PowerSpec 7.0.1 Release Contents

21-Jun-19

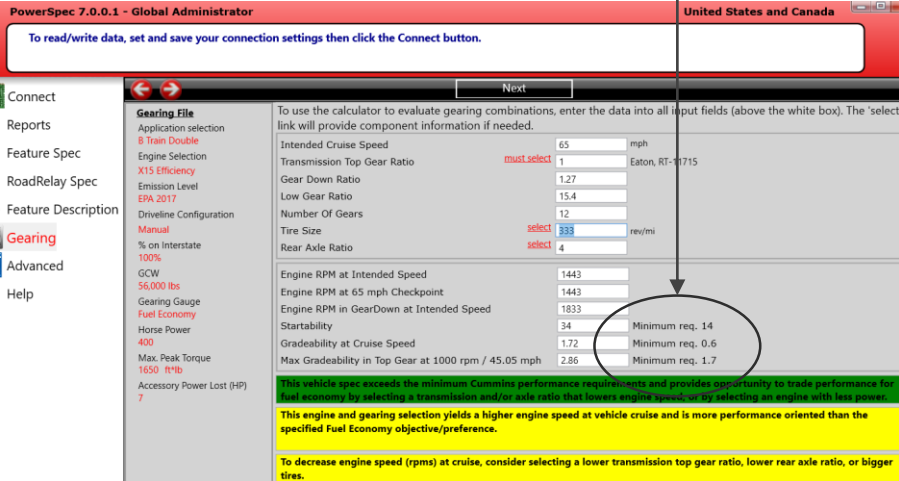
- ❖ Axle Ratio limits

1. Removed the minimum Axle ratio value (2.64) restriction for Endurant
2. Removed the Axle range check for ISX15/12 Smart Advantage (2.64 - 2.93)
3. Changed the Axle range from 2-16 to 1-16
